**Item No:** 3.2  
**Title:** DA/58327/2020 - 15 Lynnette Crescent East  
Gosford - Alterations and Additions to the existing  
Dwelling, Carport, Cabana, Inground swimming  
pool and retaining structures  
**Department:** Environment and Planning

17 September 2020 Local Planning Panel Meeting

Reference: 011.2020.00058327.001 - D14107188  
Author: Gary Evans, Principal Health and Building Surveyor  
Scott Rathgen, Section Manager, Central Coast Building Certification North  
Approver: Brian Jones, Unit Manager, Environment and Certification

**Figure 3: The proposed site plan**

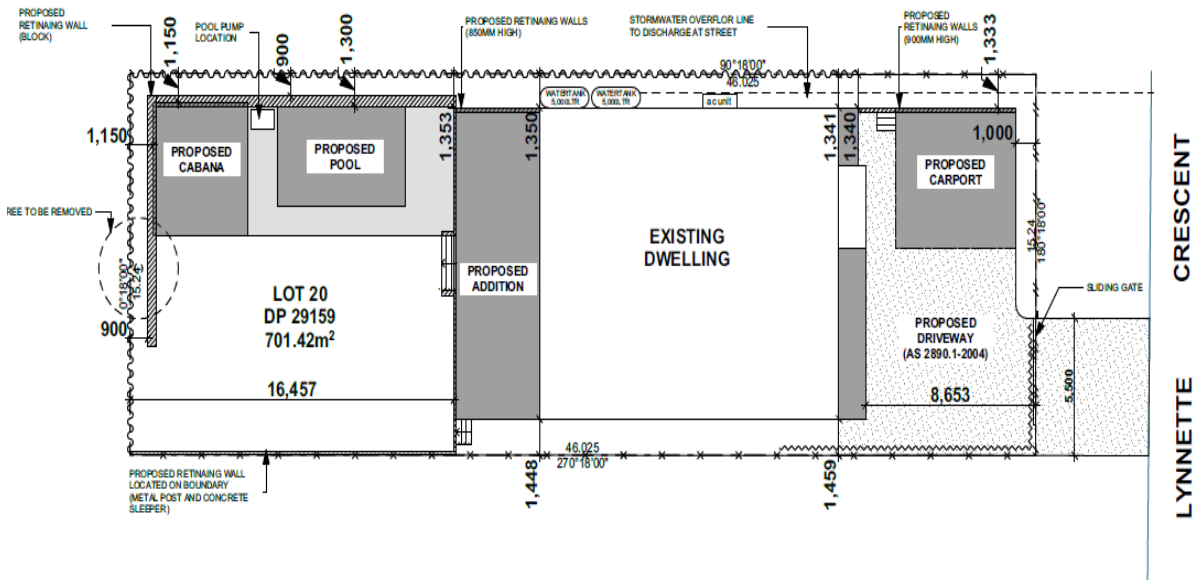
- The proposal seeks a significant variation to the required primary road setback to permit the development. The significant variation is not supported and is considered out of character with the existing streetscape and non-compliant with relevant setback objectives of Chapter 3.1 “*Dwelling Houses, Secondary Dwellings and Ancillary Development*”;

- The proposal includes significant earthworks within the rear yard area of the allotment. The extent of the proposed earthworks and subsequent retaining, could be reduced via a more balanced level of cut and fill, thereby achieving an improved design outcome;

The proposal seeks a significant variation to the required primary road average setback to permit the development, noting that without the proposed carport structure, the proposal would be compliant with required setback controls. The proposed carport structure seeks a reduced setback of 1.0m in lieu of the required 9.2m (being 1m behind the required average setback of the adjoining dwellings).

- The proposed carport, given its minimal setback to the primary road boundary, is considered to be inconsistent with the setback pattern displayed by adjacent development. This inconsistency is considered to have the potential to detrimentally impact the streetscape character within Lynnette Ave as indicated previously within the report.
- The proposed carport structure, given its minimal primary road setback in conjunction with the significant garage door opening of the attached garage, will result in a development that is considered to be visually obtrusive and dominating when viewed from the street frontage.

The proposal seeks a variation to permitted fill amounts within the rear yard area. The proposal seeks to extend fill 0.8m in depth to the southern allotment boundary, with this fill to be retained at the boundary line.

- The proposed fill amount is excessive when considering that a more balanced cut and fill ratio could easily be provided for in the proposed design, therefore reducing required fill amounts;

- The positioning of the retaining wall on the southern allotment boundary is inconsistent with the objective of minimising the provision of excessive fill amounts and subsequent retaining structures on the allotment boundary;

- The combined height of the proposed retaining wall in combination with a 1.8m high dividing fence, is considered to impact upon the solar access and general amenity of the adjoining property to the south of the site. It should be further noted that a submission from the adjoining landowner has been received with respect to this issue.

Staff sought to negotiate an appropriate outcome with the applicant regarding the proposed primary road setback for the carport structure. The applicant agreed to minor changes to the development to address the significant departure from the primary road setback controls. These changes included an increase of 0.36m to the primary road setback (1.36m) and a reduction in roof pitch for the carport structure.

As with the primary road setback variation listed above, staff sought to negotiate the issue of the proposed fill and subsequent retaining wall height and location with the applicant. The applicant agreed to a minor change decreasing fill to a depth of 0.6m (increasing cut by 0.2m). However, the applicant maintained that fill should be retained at the southern allotment boundary, rather than providing a boundary setback of 1.0m as requested by assessing staff.

Figure 4: The proposed eastern (street) elevation

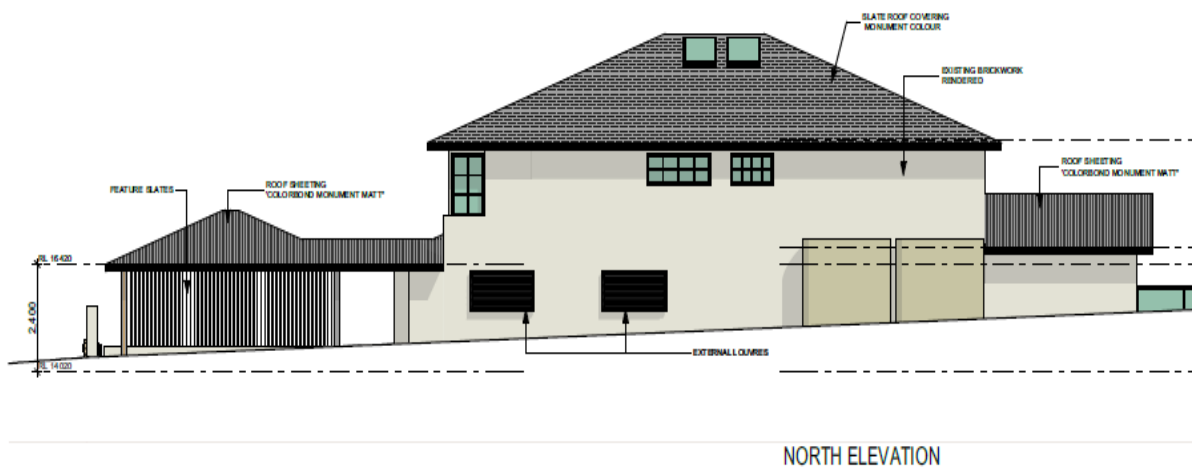
It is considered that the development proposal, given the positioning of the substantial carport within the primary road setback area, will have significant visual impact upon the existing streetscape in Lynnette Crescent.

As shown in the photomontage in Figure 7 above, and within figures 8-10 below, the proposal creates a significant visual impact when viewed from the street frontage and the adjoining dwelling to the north. In this regard, the development proposal is not considered to meet the relevant desired future character statements relating to the maintenance of existing setbacks displayed by surrounding development, avoidance of wide dominant garages and driveways and provision of a "traditional" street address.
